P 516413
A REPAIR

ON-SITE SEWAGE DISPOSAL SYSTEM HOWARD COUNTY HEALTH DEPARTMENT BUREAU OF ENVIRONMENTAL HEALTH

SUBDIVISION: Greenwood Farms LOT NUMBER: 49

GREENWOOD FARMS Lot 49 P.L. CONCEPT PLAN FOR REPAIR

P 516413

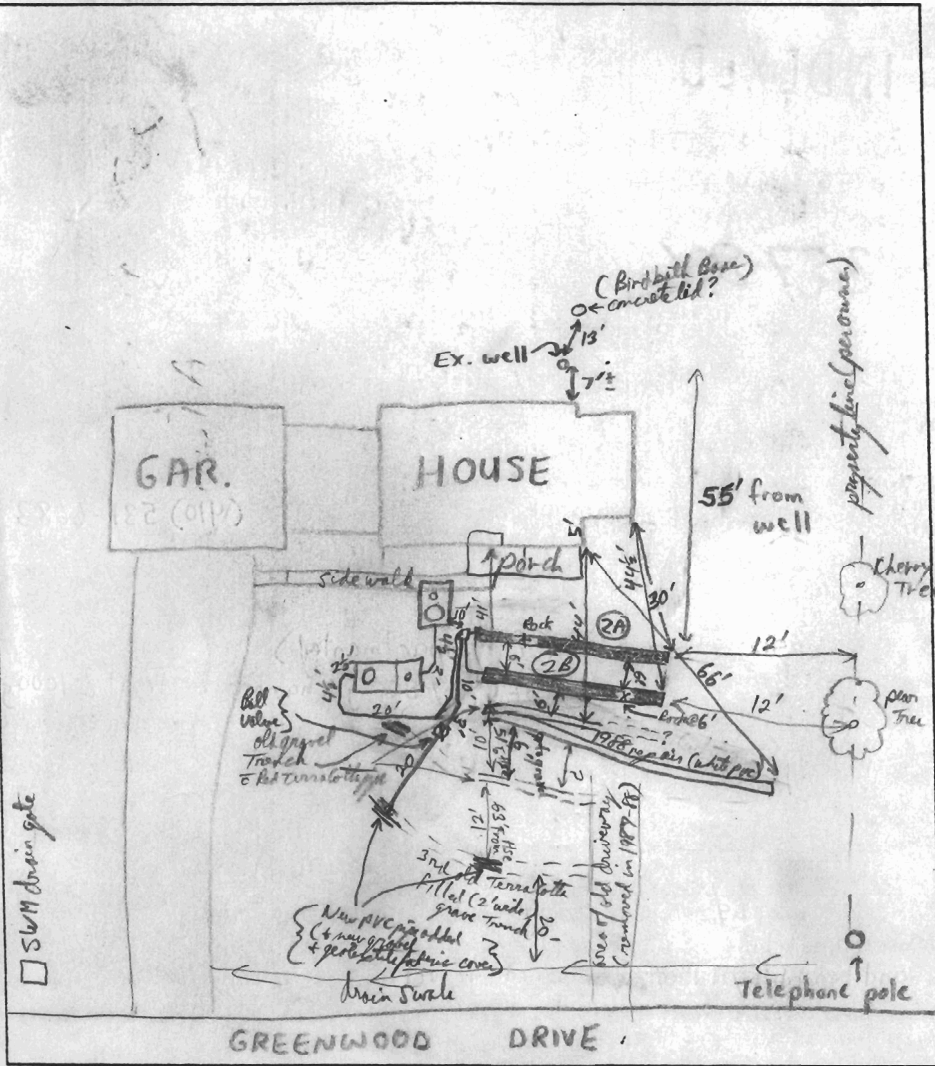
PRE-CONSTRUCTION INSPECTION: 11/15/01 - WENT OVER LAYOUT W/INSTALLER, SPRAY PAINTED & TAPED OFF IMPORTANT MEASUREMENTS, OK TO PROCEED PER PLAN - PLAN MAY CHANGE - (SRU)

11/16/01 - on excavation I found 3 old gravel trenches (upper one w/ red Terra Cotta pipe intersects ground to gravel trucking) about 41' from front door of house - the third trench has wet gravel, is 5 1/2 ft from front door and has only 6 ft soil between trenches. It's Not possible to place a trench between any of these trenches (they already too close together).
 Tr 2B installed (From 5' to 6 ft below grade into mottled yellowish grey silty on Northern 15 ft length, and gravel Boulder @ 25' from North end @ Bottom) placed 3 ft of Sand Hauled Sand in 4 trenches (2B + 2A) - sand pale pink color - very clean & uniform (not over packed size @ .35-.40 mm + Uniform) Then, 6 inches of radium blue stone gravel placed on top of sand. OK, then 4" per (quantity) PVC, then 2" gravel cover sand OK @ 2.5' and geotextile fabric cover, then sand back fill - Tr 2A also OK (had one pt. stop) - 5' similar description as 2B. OK to cover both Tr 2A + 2B and S.T. + P.C. 11/16/01 Discovered a 3rd Terra Cotta pipe (2' wide) gravelled trench. Decided to use this old trench (with partial New PVC pipe to replace section excavated) instead of installing another new trench. This old line (dry, New + clean gravel) will be tied to pump system via a Ball Valve after connection to dist. Box. It can be turned off when lower line gets too full.

11/17/01 - we discovered an old lowest 4th trench (old terra cotta piped) we repaired broken clay pipe with perforated PVC @ 2 points opened and connected it to the new dist box with a Ball Valve on feeder line to allow turning it closed when old trench gets wet (wet seasons) or fails. All three feeder lines to 2 new & 1 old Trench are leveled in dist box with auto levelers. (old Trench's gravel was clean and dry)

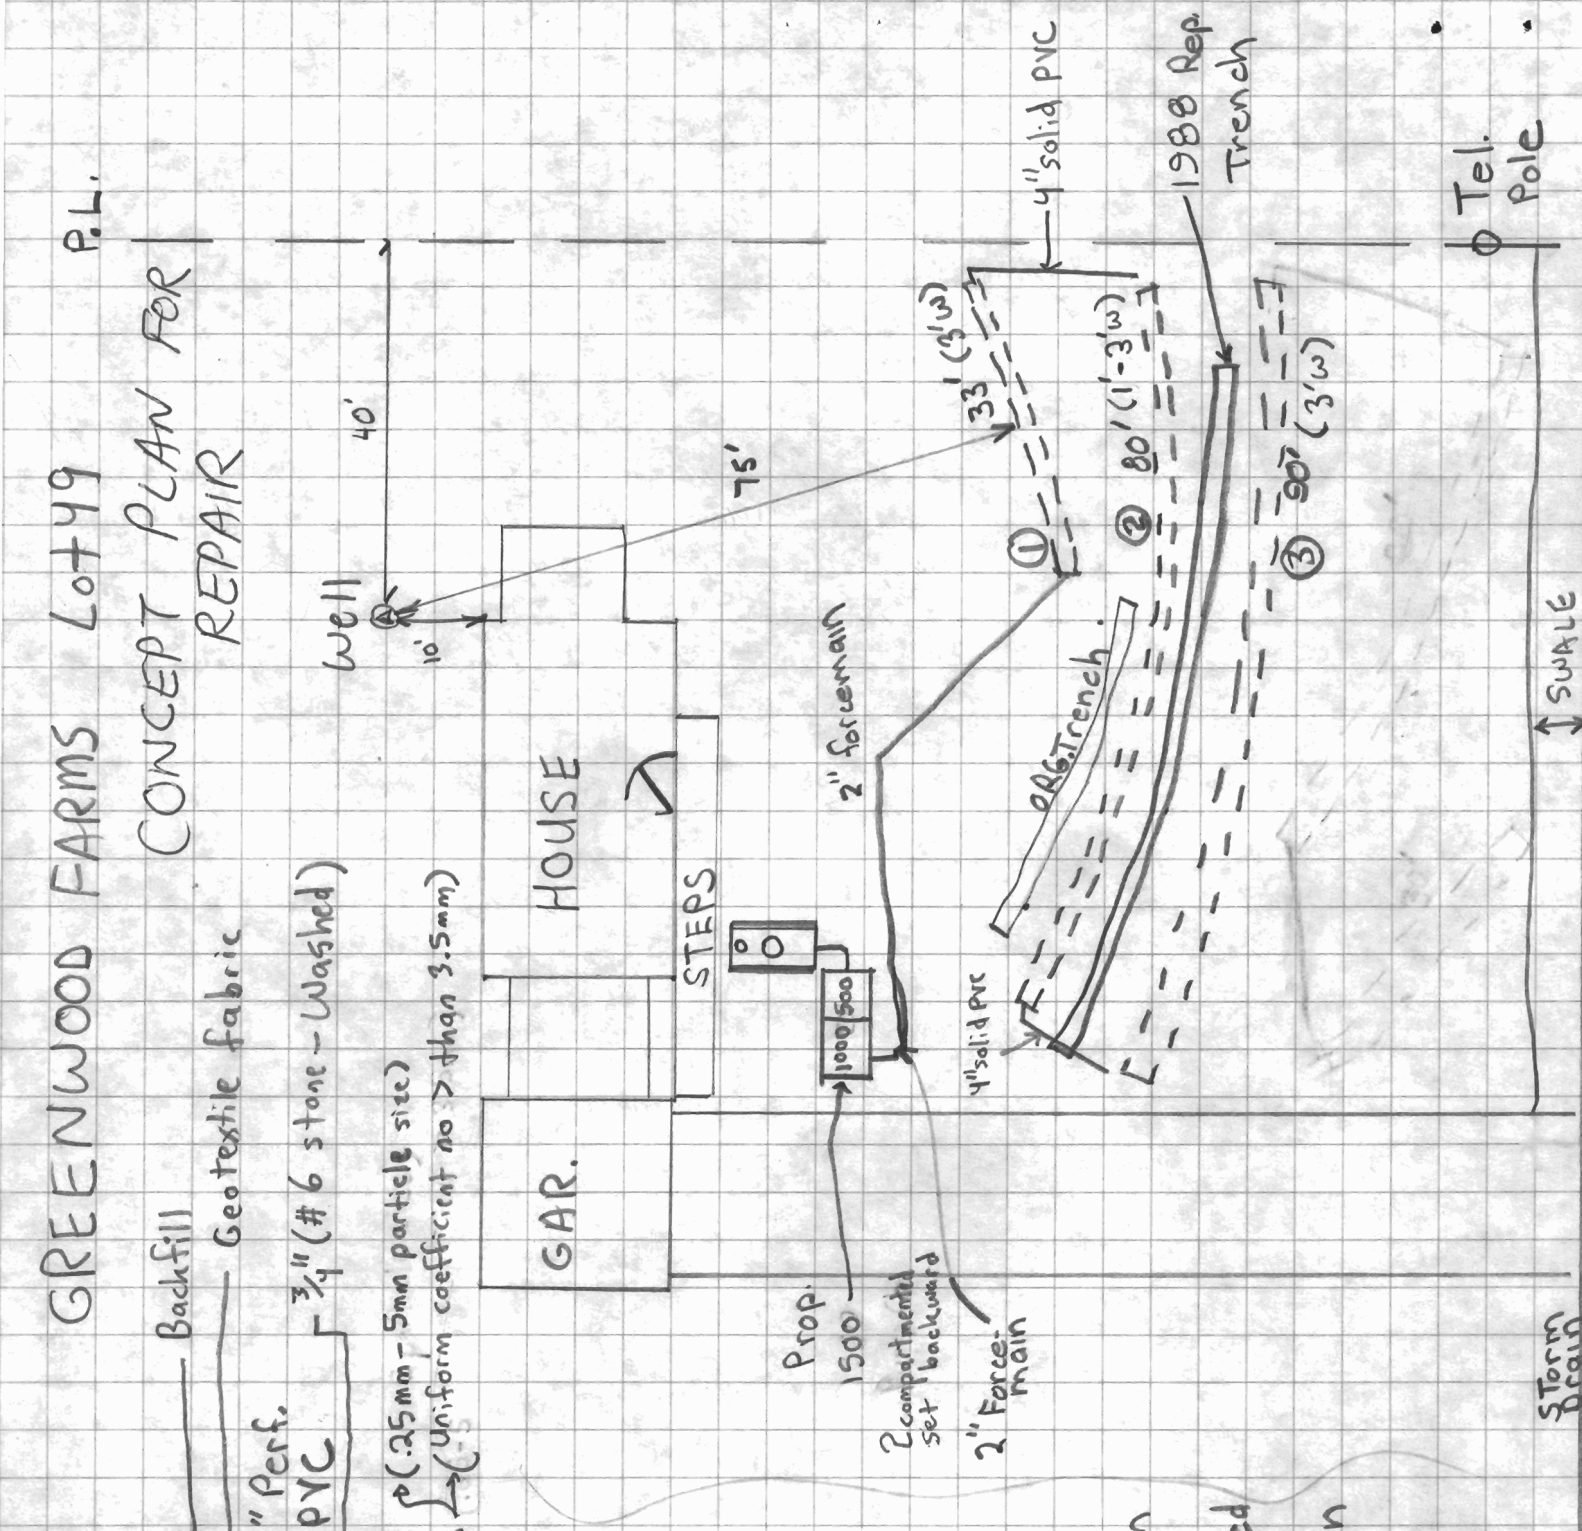
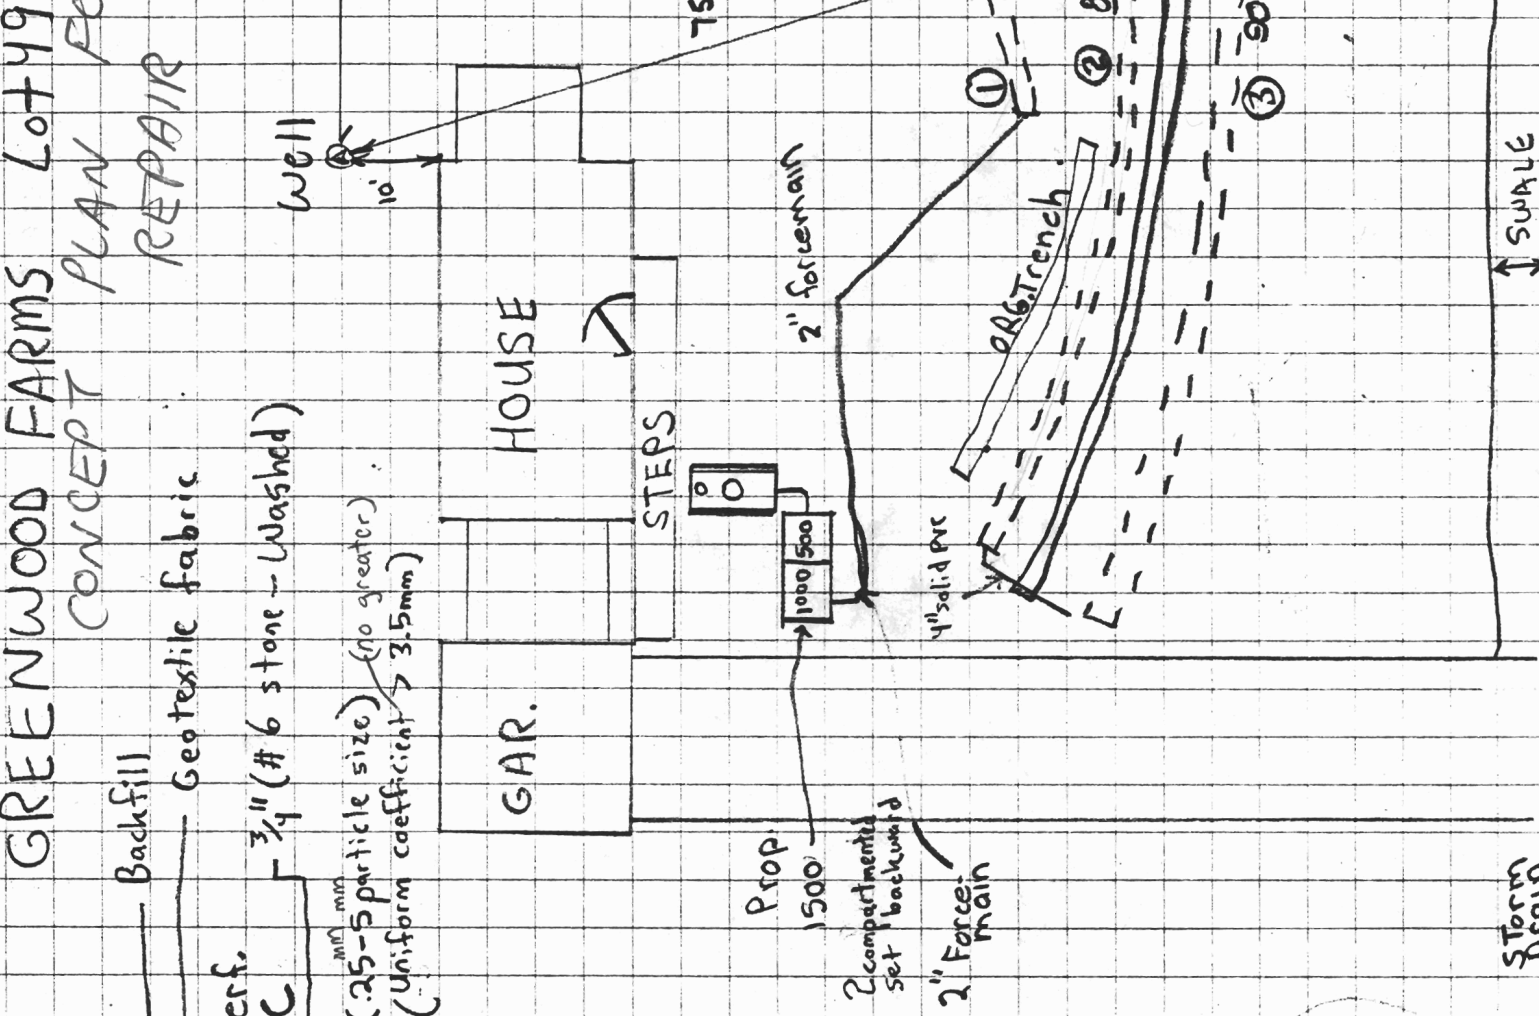
There are at least 3 old drainfield trenches (in addition to today's repair) on this property. Two original gravel trenches using red terra cotta pipe which appear to have once been 10 ft apart (where excavated in front of front door) and 41' and 51' successively in front of House. These may have been installed separately or at the same time. Between them, and running into the upper most terra cotta piped trench is a 3 ft wide gravel (with white PVC piping) trench - the 1988 repair which was 76 ft long and precisely located by older records. The upper two trenches have blacked gravel but are not wet now. The lower 3rd trench is saturated.

Parts of 80' trench may not be installed due to field location of ex. trenches.

PICTURE BELOW IS A DRAWING OF THE EVALUATION & PERC CONDUCTED BY SRK (ME) ON 5/3/00. SEE PREVIOUS FILE RECORDS FOR EVALUATIONS DONE IN THE PAST = EVALUATION & PERC TEST IN 12/87, PERC TEST IN 2/88 & 1ST PERMITTED REPAIR IN 3/88)

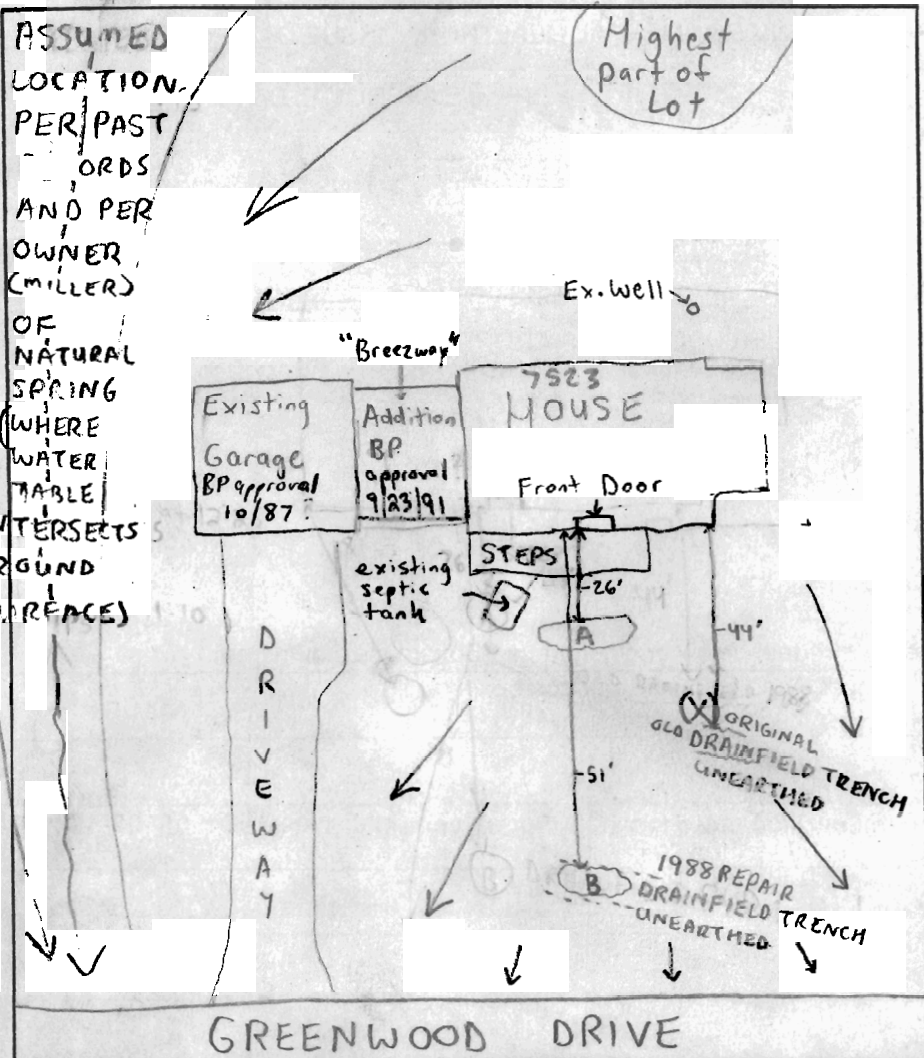
5/3/00-ARRIVED AT SITE, MET OWNER (MARY MILLER) AND CONTRACTOR (JENKINS BROTHERS) - DISCUSSED FILE HISTORY PER PRE-CONSTRUCTION INSPECTION: OWNER'S REQUEST, BEGAN EVALUATION OF FRONT YARD FOR POSSIBILITY OF A CONVENTIONAL SEPTIC SYSTEM REPAIR - ATTEMPTED PERC HOLE 44' FROM HOUSE, UNEARTHED DRAINFIELD BY ACCIDENT (X) IT PRESUMABLY WAS PART OF THE ORIGINAL SYSTEM INSTALLED WHEN HOUSE WAS 1ST BUILT. THIS SAME AREA WAS EXCAVATED IN 12/87 (SEE 12/87 EVALUATION & PERC TEST) - EXCAVATED PERC HOLE IN LOCATION A, APPROXIMATELY 26' FROM HOUSE SEE PERC TEST DATA SHEET DATED 5/3/00 FOR SOILS EVALUATION AND SOILS WATER TEST.

INSPECTION COMMENTS: LEFT SITE TO GO TO ANOTHER FIELD INSPECTION - 5/3/00 - RETURNED TO SITE, NOTICED WATER LEVEL IN HOLE A HAD RISEN APPROXIMATELY 3', BEGAN PERC TESTS AT 12:34pm SEE PERC TEST DATA SHEET - HOLE A FAILS FOR CONV. SYSTEM - EXCAVATED IN LOCATION B BUT UNEARTHED DRAINFIELD TRENCH PRESUMABLY INSTALLED IN 3/88. DISCUSSED LIMITED SITE CONDITIONS WITH OWNER AND POSSIBILITY OF EXPERIMENTAL / NON CONVENTIONAL SYSTEM REQUIRED. EVALUATED IDEA OF POTENTIAL REPAIR AREA IN REAR OF HOUSE BUT ADJACENT NEIGHBORING SEPTICS AND WELL LOCATION PROHIBIT ANY POSSIBILITIES. LEFT SITE, RETURNED TO OFFICE AND DISCUSSED W/ CRAIG WILLIAMS THE ISSUES ENCOUNTERED. SEE DOCUMENTED DISCUSSION AND CONCLUSION ATTACHED DATED 5/3/00. 5/3/00 - SITE PLAN DRAWN TO COMBINE ALL TEST NOLE INFO FROM ALL YEARS PAST ON ONE PAGE - SRK

4513581

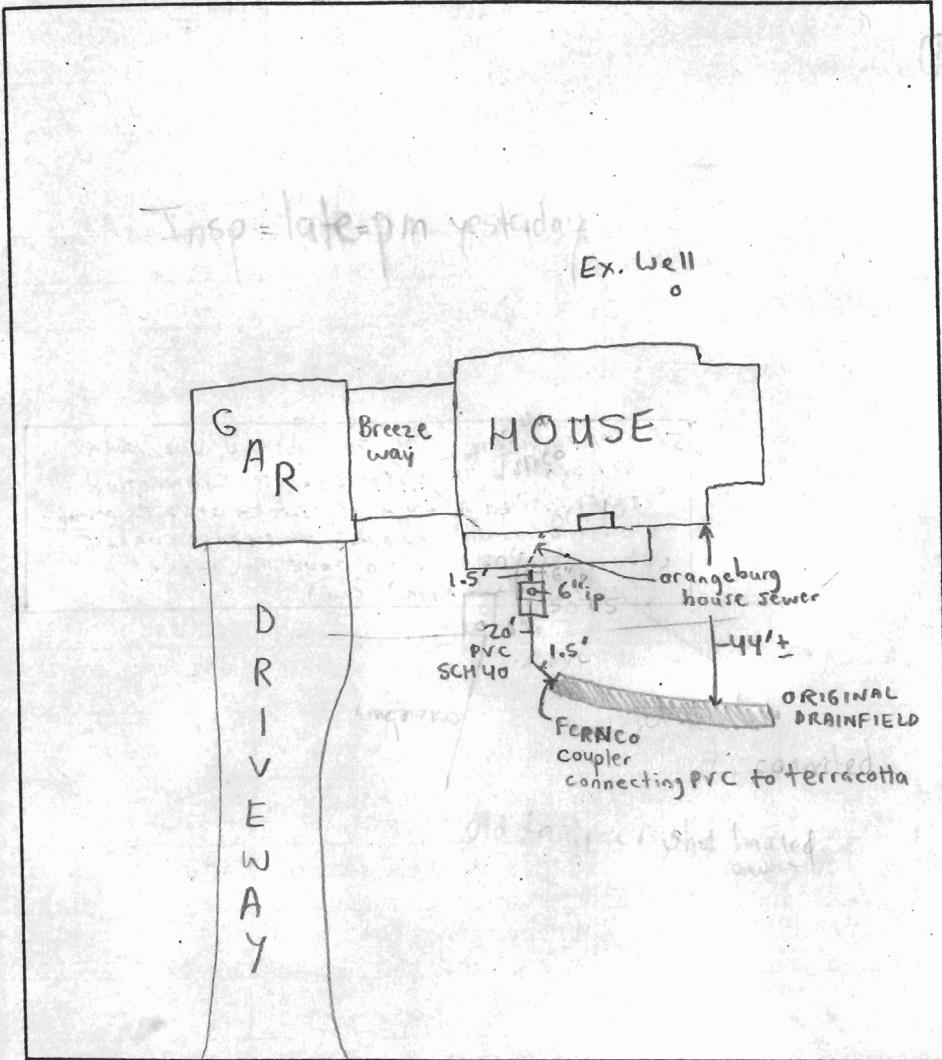
5/22/00 REVISION - OK TO INSTALL ONE 1500G TOP SEAMED TANK FOR GRAVITY CONNECTION TO EXISTING TRENCH. (CONTRACTOR'S RECOMMENDATION/OWNER'S REQUEST TO REDUCE CURRENT COST, PROVIDE TIME TO SAVE FOR MORE COMPLETE REPAIR) (CW)

Existing tank in disrepair - abandon and replace with 2 - 1250 gallon top seamed septic tanks in series; take current disposal trench(s) out of service and attempt to reconnect (likely via use of 2nd tank as pump pit) to original incompletely used trench in front of house. If it is impractical to make this connection, then seal outlet to second tank and manage as holding tank until a determination can be made on an alternative disposal field.

INSPECTION COMMENTS: 5/24/06 - ARRIVED AT SITE, CONTRACTOR AT REQUEST OF HOMEOWNER COVERED ALL WORK WITHOUT INSPECTION. HOMEOWNER AWARE AND OK WITH THIS, CONTRACTOR REPORTS OLD SEPTIC TANK CRUSHED, EXTRACTED AND HAULED AWAY, CONTRACTOR INSTALLED NEW SEPTIC TANK AND TIED INTO TERRACOTTA PIPE WITHIN ORIGINAL TRENCH, THIS SYSTEM IS NOT A PERMANENT SOLUTION BUT MAY HELP ALLEVIATE SITUATION TEMPORARILY, DRAWING ABOVE IS INFO
